Agenda
Heritage Preservation Commission
City Of Edina, Minnesota
Community Room, Edina City Hall
Special Meeting
Thursday, June 2, 2022
6:30 PM

Subject: Update to COA H-20-6: 4630 Drexel Ave, Changes to Building Material and Replacement of Chimney

Subject: Amendment to COA H-20-6, 4630 Drexel Avenue, proposed roof material and replacement/reconstruction of chimney

SIDE DETAIL
SCALE: 1/2" = 1'-0"

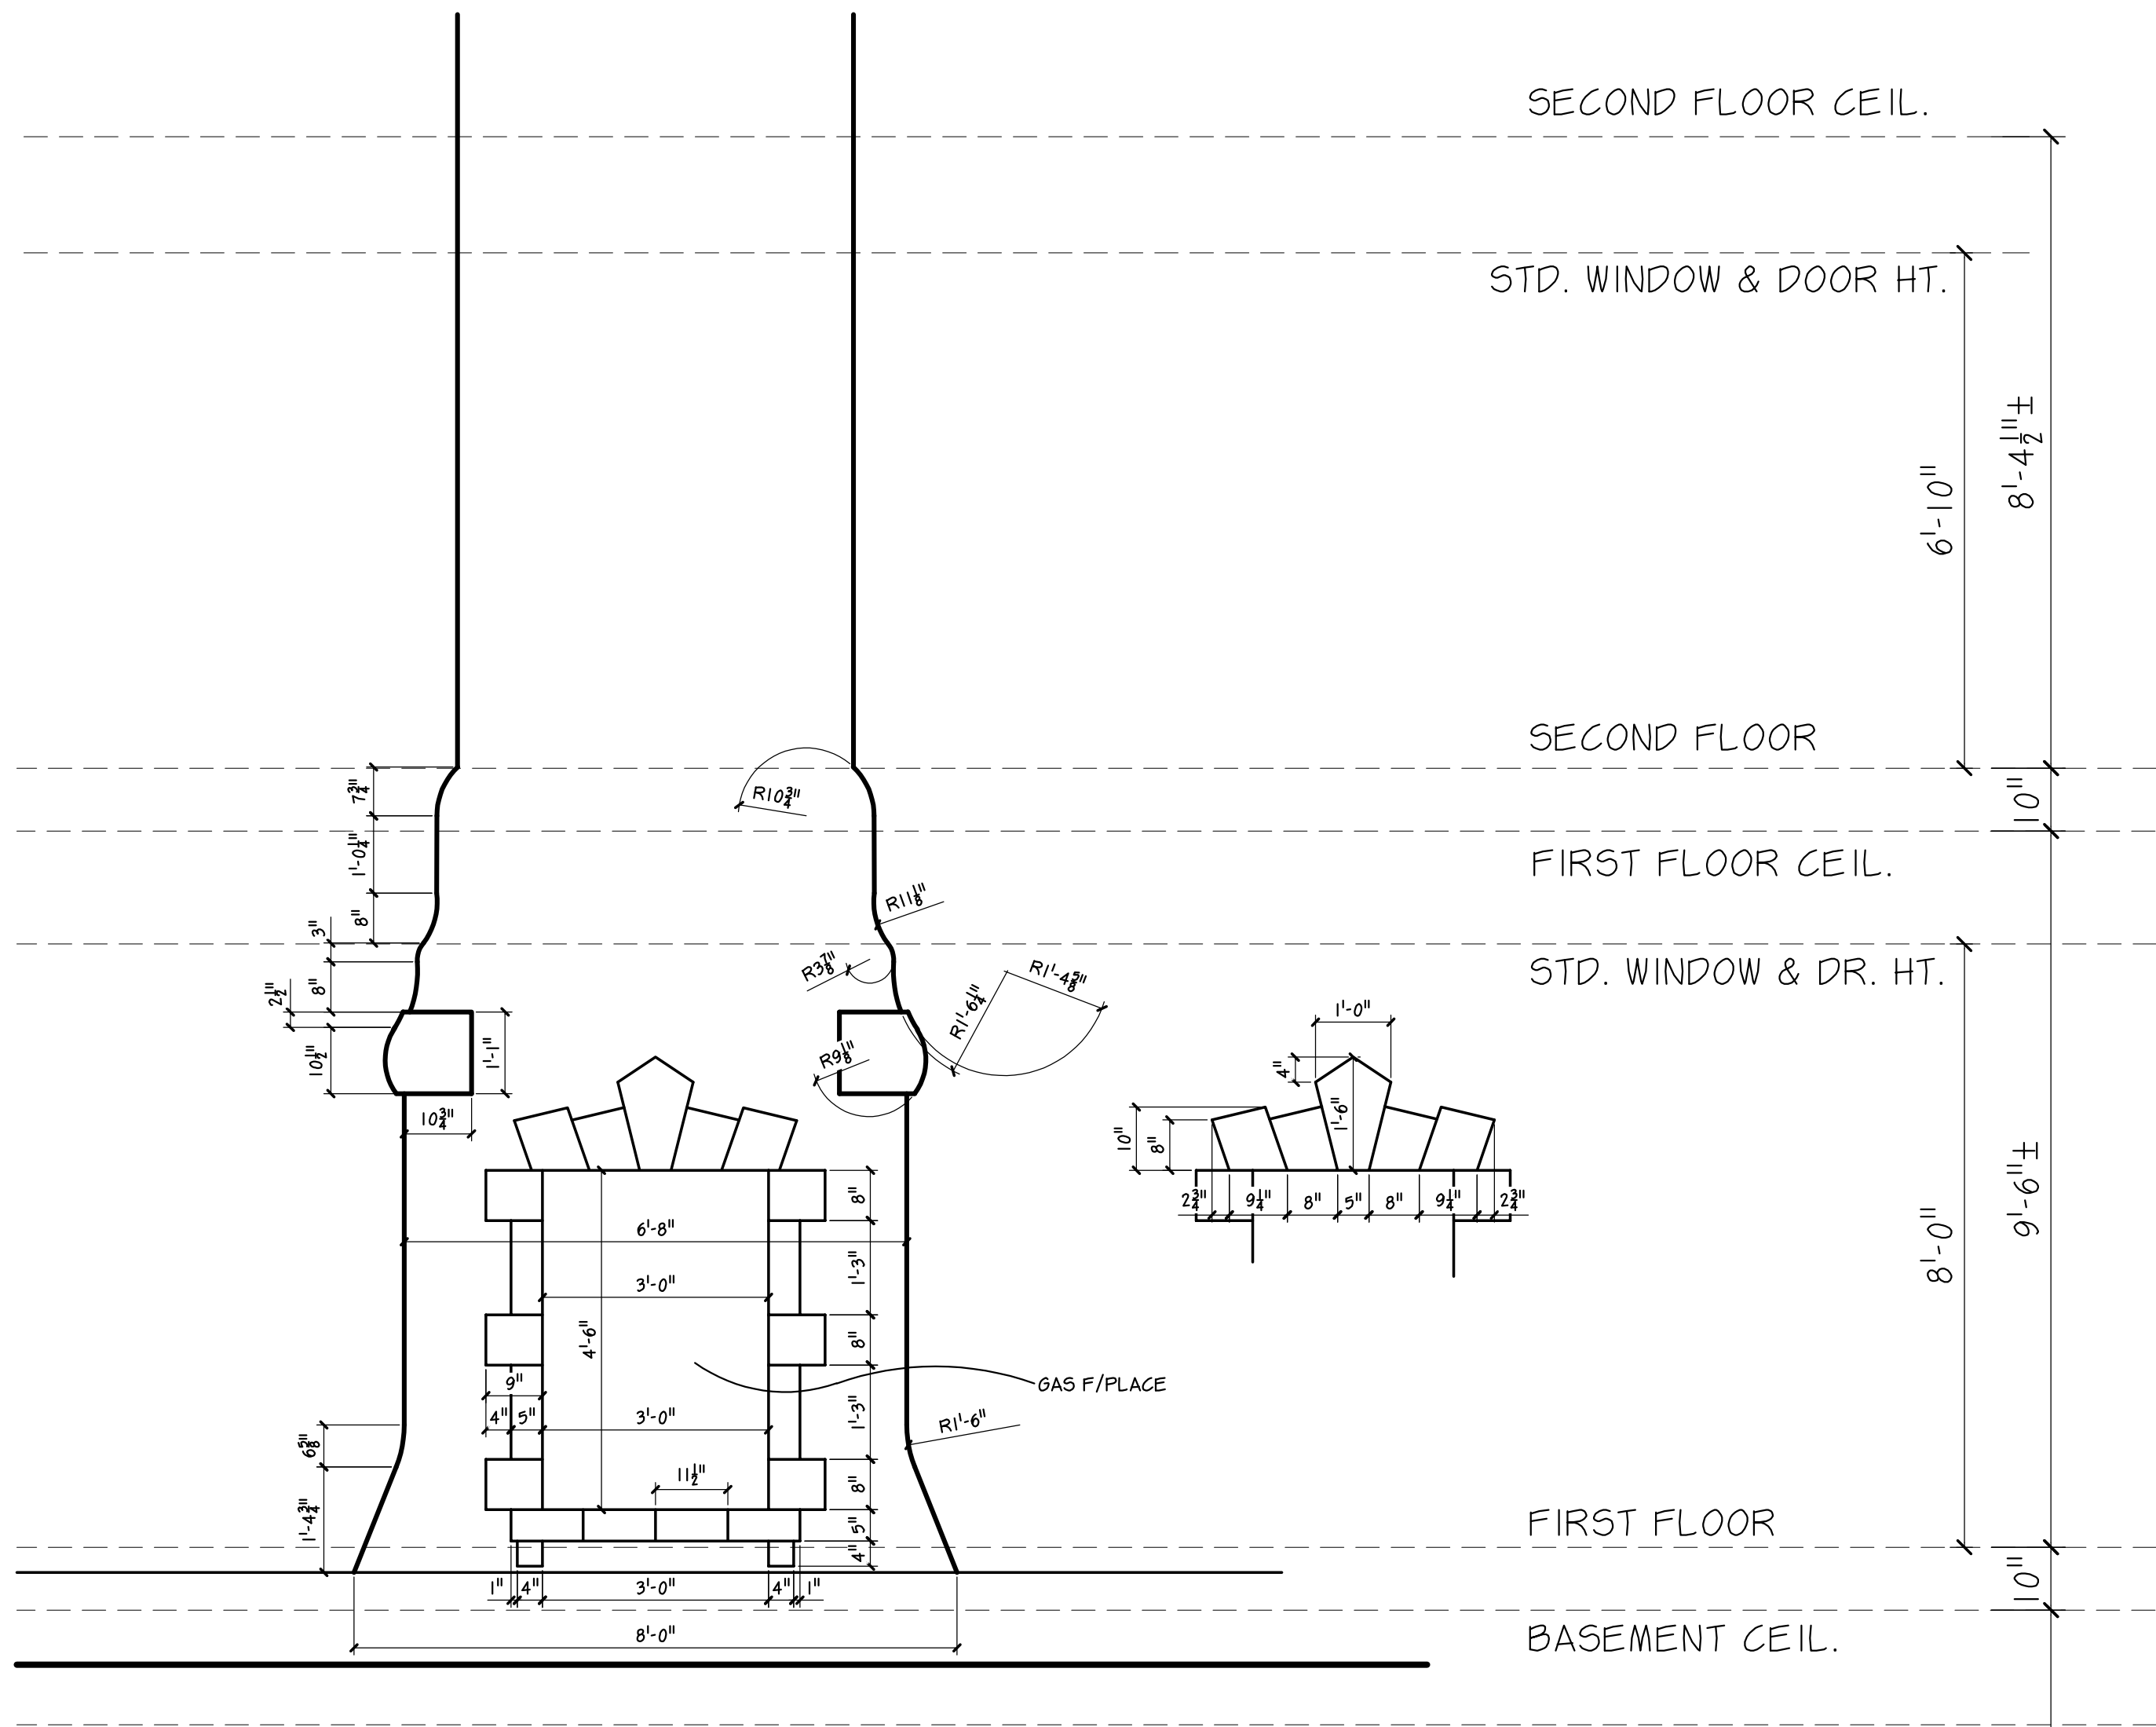
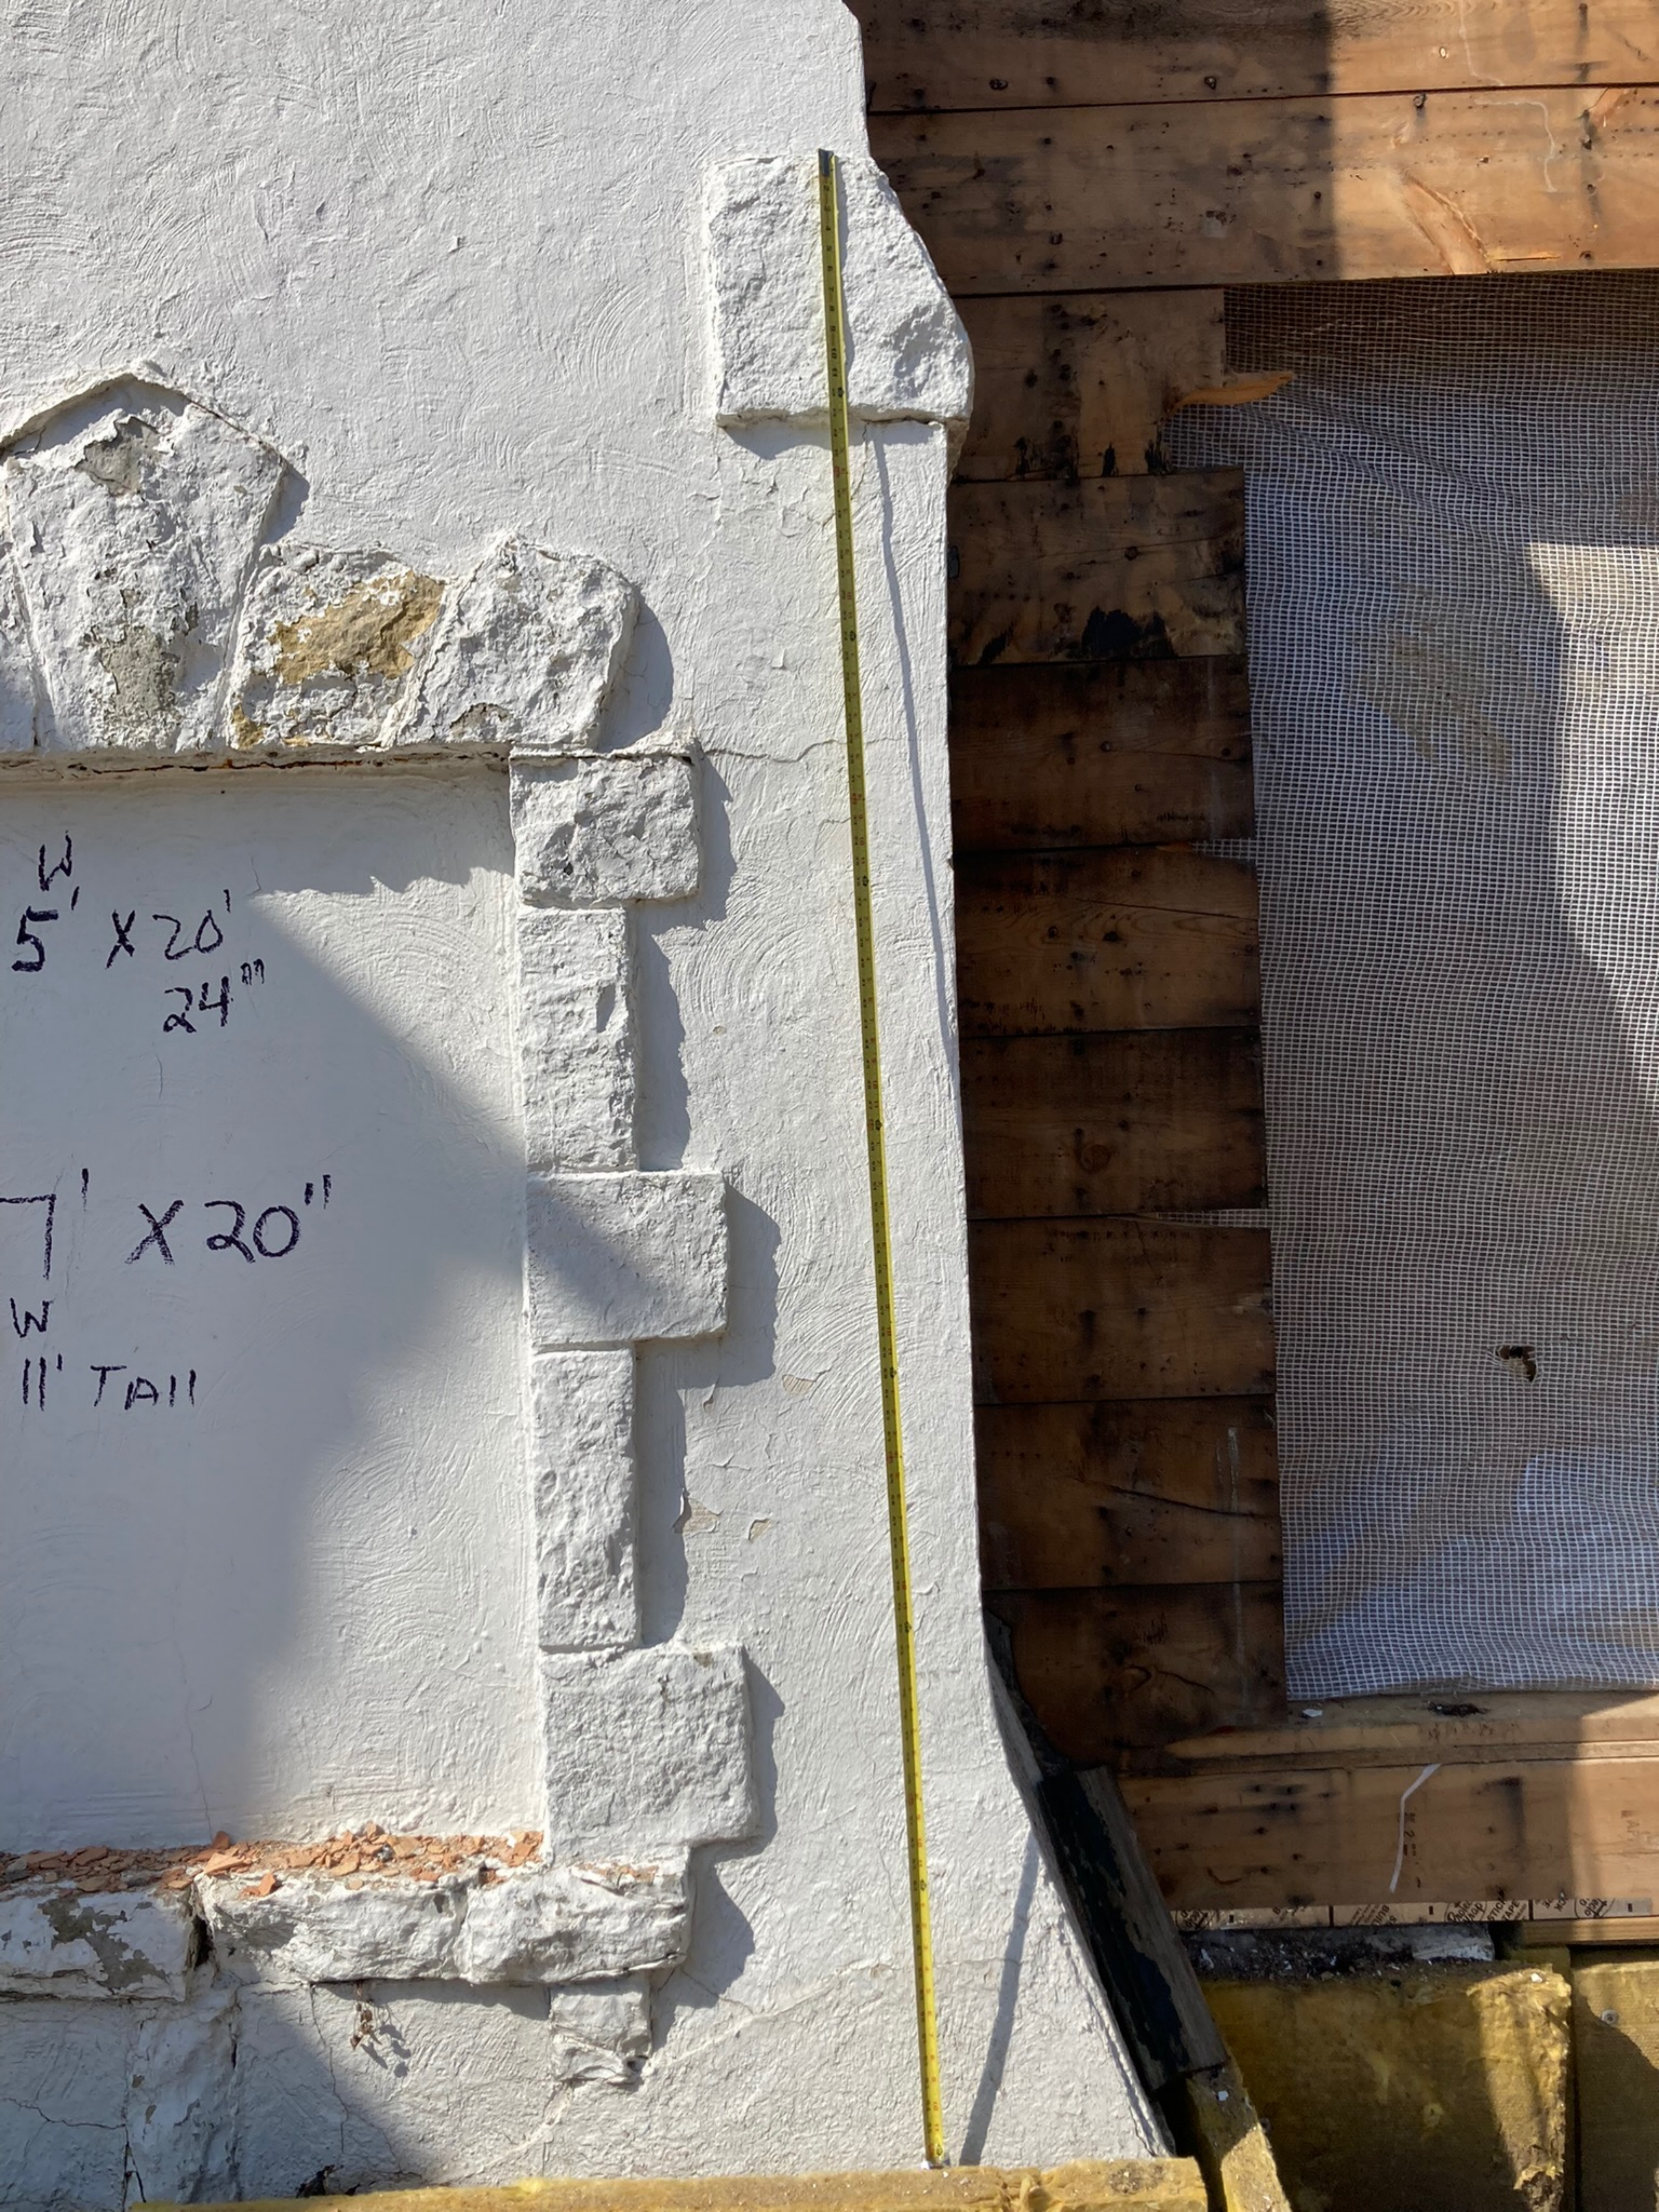
The existing chimney has been removed from the subject property due to health and safety reasons and the demolition was ordered by the city's Chief Building Official. The applicant is proposing to replace the chimney by constructing the new chimney with framing materials and finish it with stucco and stone to match the original structure.

I don't think repairing the chimney is an option and it could be dangerous. The HPC will need to determine how the chimney gets rebuilt. It was stucco. To rebuild the chimney it could be framed with wood, sheathed with wood, lathed, cemented, brown coated with plastered and stucco. When the chimney is complete the chimney will look very close to what it looked like in the past. The chimney could be rebuilt with block or brick then lathed, cemented, brown coated with plastered and stucco. Again, it will look the same as it did in the past.

I have reviewed the information you provided regarding treatment of the chimney on the house located at 4630 Drexel Avenue in the Edina Country Club District. The applicant proposes to demolish the existing chimney, which appears to be original construction and represents a distinctive (i.e., historic character defining) architectural feature, and replace it with a new chimney that matches the original. The photographs and written information provided by the applicant document the extent of physical deterioration and make a strong case for replacement of the old fireplace and chimney. The city's building official has also determined that the existing structure is unsafe. **As we discussed earlier, the chimney and roofing issues can be handled as amendments to the current COA.**

The proposed work is consistent with the Secretary of the Interior's Standards for Rehabilitation, which are the required basis for COA decisions (and are incorporated in the Country Club District Plan of Treatment). The preferred treatment strategy for dealing with failed structural systems is repair rather than replacement; however, in this case it seems clear that total replacement of the chimney is necessary in order to comply with current building safety code requirements. The standards for rehabilitation state that whenever replacement of a deteriorated building feature is necessary, the new construction should match the architectural characteristics of the feature being replaced. The current standard of practice is to retain as much original masonry as possible while replacing the exterior finish (stucco) with new material that duplicates the original as closely as possible.

Staff recommends the approval of the reconstruction of the chimney to match the materials and detailing of the original chimney as proposed by the applicant based on the findings above.

In my opinion, demolition of the existing chimney is an appropriate treatment for this property. Based on the plans presented, the new chimney will match the original in size, shape, material, and surface finish, restoring an important historical detail that would otherwise have been lost.
